Design statement

Osborne Yard

Land at Oldham Road, Manchester

Supporting design statement for Section 73
application

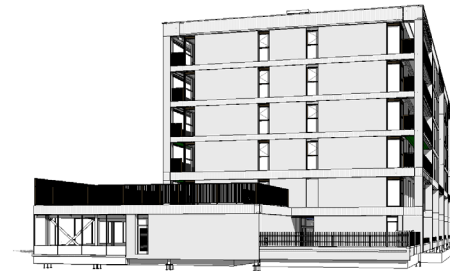
APD-B is clear in prescribing, 2.5m from the ceiling of the highest storey served by the shaft to the opening is a minimum requirement. The smoke shafts have been increased in height to ensure compliance with current fire strategy requirements and to maintain effective smoke extraction performance. This adjustment reflects coordination with the fire engineer and mechanical consultant, ensuring that the shafts terminate at a level that avoids recirculation and meets the required free air discharge criteria.

Each shaft is located approximately 2.5 m back from the parapet line. This setback significantly reduces visibility from street level:

- Close-range views: The parapet and roof edge screen the shafts, so they are largely concealed when viewed from the immediate public realm.
- Mid-range views: The shafts appear as part of the roofscape rather than as isolated projections, blending into the building massing.

The overall building height and parapet depth diminish the relative scale of the shaft projections. From most pedestrian viewpoints, the shafts are subordinate elements, perceived only in very oblique or distant views.

OLDHAM ROAD
GA Building plan – location of tank in blue hatch.

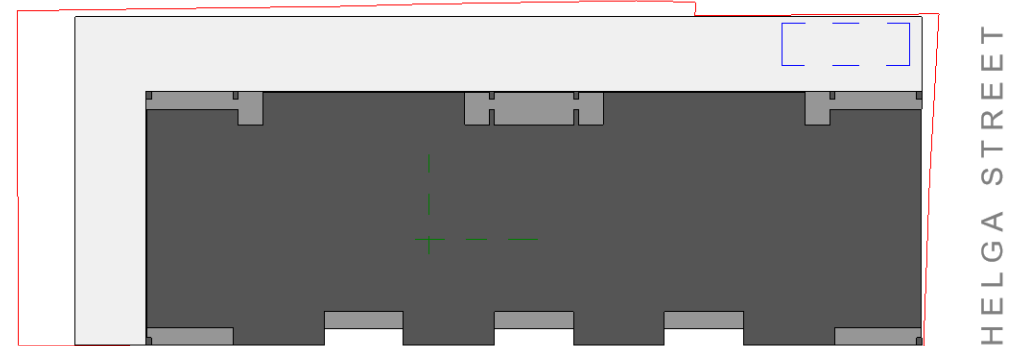
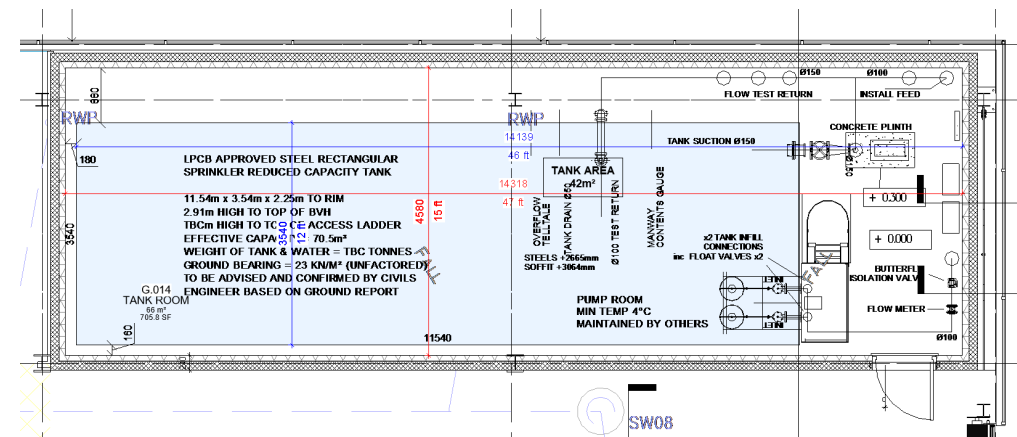
An OH2 Standard Sprinkler System has been incorporated in accordance with BS EN 12845:2015 + A1:2019, as required for buildings of this classification where car park areas exceed 100 m². This requirement was not addressed within the original planning submission, as it was initially assumed that the existing live water main would provide sufficient pressure for a mains-fed system. Subsequent hydraulic analysis confirmed this to be unfeasible, necessitating the provision of a dedicated sprinkler water storage tank. The tank is substantial in both scale and cost.

The tank and associated plant have been positioned within the north-west section of the car park, selected to meet specific operational and structural criteria, including:

- Accommodation of significant static load.
- Provision of a fire-resistant, temperature-controlled enclosure.
- Compliance with access and maintenance requirements.

The inclusion of this facility results in the loss of six standard parking bays; however:

GA Plan – Proposed.

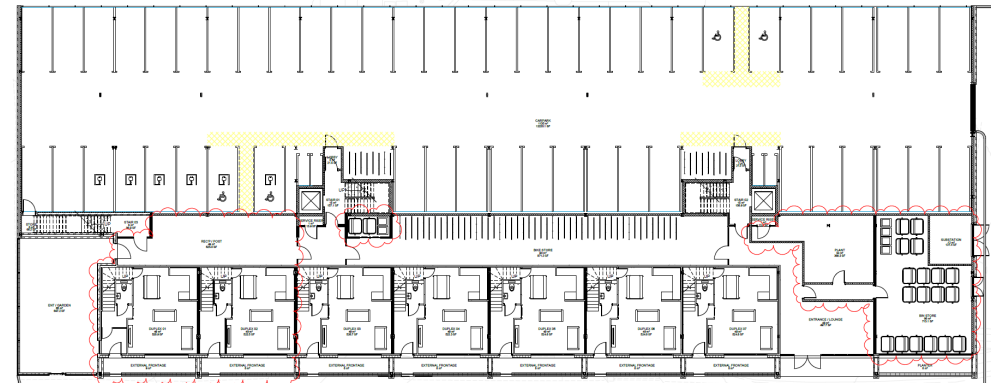
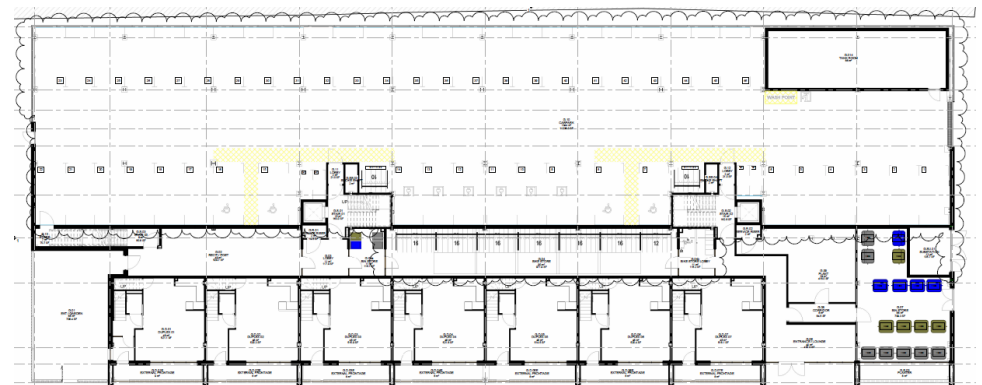
- 45 parking spaces in total
- Retained 4 accessible car spaces are proposed – equating to 9% provision
- 4 motorcycle spaces are proposed to be retained (now proposed to be shared with accessible bikes)
- Increase to 120 cycle parking spaces
- 8 motorcycle/accessible/cargo cycle bays within car parking area;
- 112 spaces within double stacked cycle racks.
- Cycle repair area/cycle lockers/cycle wheel wash

- Additional secure cycle parking spaces exceeding minimum local and national standards.
- Covered and weather-protected storage facilities to ensure year-round usability.
- Improved access routes and wayfinding to integrate cycle facilities with the wider site layout.
- Supporting infrastructure, such as anchor points and lighting, to enhance security and user convenience.
- Rearrangement of the disabled bays to ensure locations present improved ease of access to lobbies.

These measures are consistent with the principles of the National Planning Policy Framework (NPPF) and local transport policies, which encourage modal shift towards sustainable transport modes. The strategy ensures that the loss of six standard car parking bays is offset by improved facilities for cyclists, reducing reliance on private vehicles and contributing to the overall sustainability of the development.

GA Plan – Proposed. Permeable areas indicated.

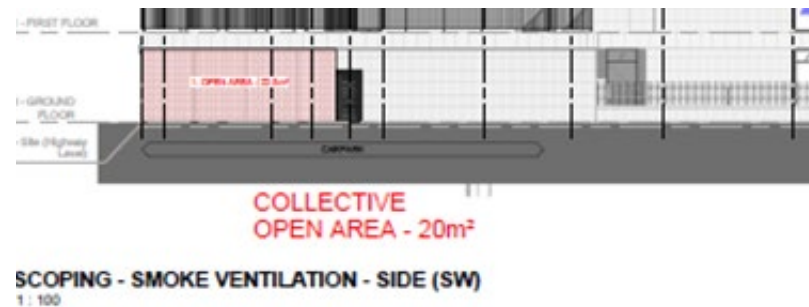
The originally approved scheme proposed solid, impermeable gable treatments to the car park, based on the assumption that the open rear elevation—substantial in scale—would provide sufficient natural ventilation. However, further technical review has confirmed that compliance with the requirements for naturally ventilated car parks cannot be achieved through a single open aspect alone, regardless of its size.

In accordance with relevant guidance (e.g. Approved Document B and BS 7346-7), natural ventilation strategies must facilitate crossflow of air between opposing elevations. This requires a minimum percentage of open area on each elevation to ensure effective smoke clearance and air movement.

To meet these requirements, the gable elevations must be materially rearticulated to incorporate permeable finishes in designated zones of the car park. These changes are necessary to achieve the required free area for smoke ventilation, while also addressing aesthetic integration, security, and climb prevention.

On the left-hand side (LHS), the permeable treatment would extend to the blue line (approx. 7.5m). While this introduces a view through the elevation, the location is set approximately 25m back from Oldham Road and is visually shielded by the adjacent industrial shed and the corner of the existing block.

On the Helga Street elevation (approx. 6m), the permeable area is entirely screened by the OH2 sprinkler tank wall, which sits internally and is finished in black, rendering the treatment visually inconsequential from the public realm.

Permeable proposal.

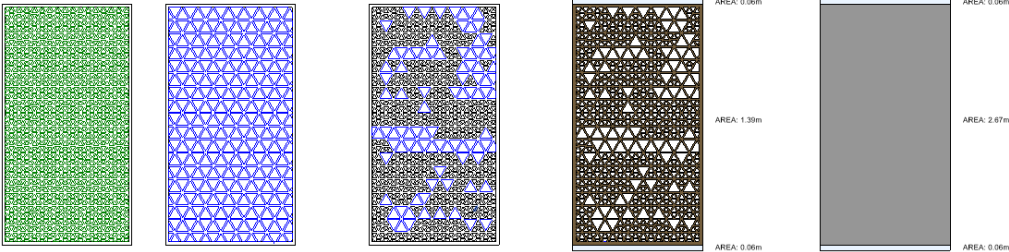
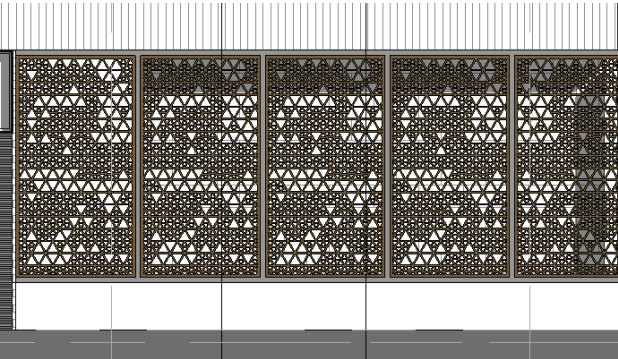
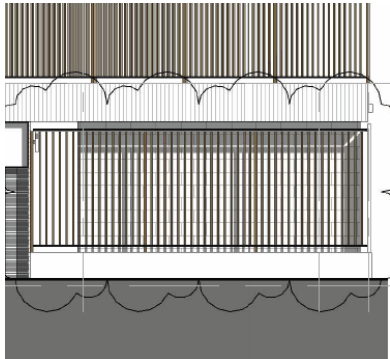
Following feedback from the Local Planning Authority, a preference was expressed for perforated panel systems. In response, we undertook a rigorous review of various geometric forms to balance visual quality, structural integrity, and ventilation performance.

Despite these efforts, the proposed perforated systems only achieve approximately 52% of the required free area on either elevation. Increasing the aperture size would improve porosity but significantly compromise panel strength and introduce climbing risks, particularly given the proximity to the podium deck.

To resolve this, and in reference to the existing architectural language of the scheme, it was agreed that a powder-coated linear bar fencing system, colour-matched to the window frames and balustrades, would provide the optimal solution. This approach maintains visual consistency across the development, meets the required free area and protected zone criteria, and mitigates security concerns.

Proposed elevation

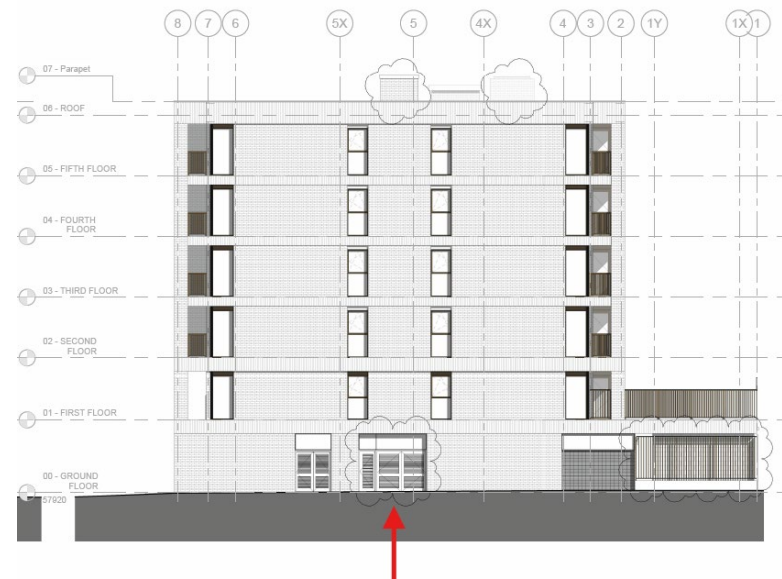
As part of the technical coordination process, the substation door specification has been revised to reflect updated requirements issued by the statutory utility provider. The original design did not fully accommodate the operational and maintenance standards now mandated, particularly in relation to access clearance, ventilation, and fire safety. The revised door design includes adjustments to:

- Clear opening dimensions, ensuring compliance with minimum access standards for equipment installation and emergency servicing.
- Ventilation provision, in line with thermal and airflow requirements for enclosed electrical infrastructure.
- Material and finish, selected to meet durability, fire resistance, and aesthetic integration with the surrounding façade.

These changes are essential to ensure the substation installation is fully compliant with current utility provider specifications and can be safely commissioned and maintained post-occupation.
